**GDA close-out for the AP1000 reactor**

**GDA Issue GI-AP1000-ME-01 – Squib valve concept and design substantiation**

Assessment Report: ONR-NR-AR-16-014  
Revision 0  
March 2017

Figure 2: 8 inch squib valve parts

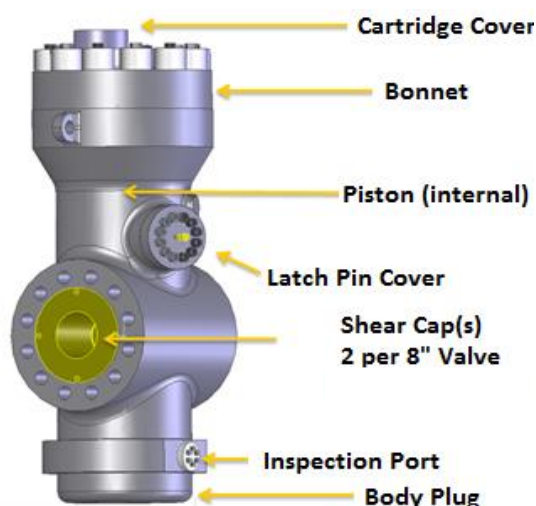
### Action 7-1: Provision of detailed evidence that an adequate visual inspection can be carried out on the 8 inch squib valve design

411. This aspect of the GDA issue concerns itself with the ability of operators to visually examine the internal surfaces of the shear cap. The 8 inch squib valve contains an inspection port. Westinghouse stated within its squib valve safety case (Ref. 10) that the inspection port can be used to undertake the visual inspections referred to within the ASME OM Code (see Section 4.2.4 for further information).
412. Figure 2 identifies a number of 8 inch squib valve parts, including this inspection port.

413. The inspection port is largely used to determine whether fluid is present in the area below the shear caps – indicating leakage. A concern, raised by ONR during Step 4, was related to inspection of the shear caps. The squib valve drawings for the 8 inch valves appear to show only a narrow area between the shear caps, which may result in difficulties in adequately inspecting the condition of the shear caps via the inspection port, for example using a probe. However, I judge that the removal and disassembly of at least two valves every two years should provide a licensee with the means to adequately inspect the condition of the shear caps at appropriate outages. The condition of those valves inspected should be used as indicators for the other valves within those systems.

415. Consequently, I am content that the current ASME OM Code requirements are sufficient to provide appropriate assurance of the 8 inch squib valve shear cap condition.
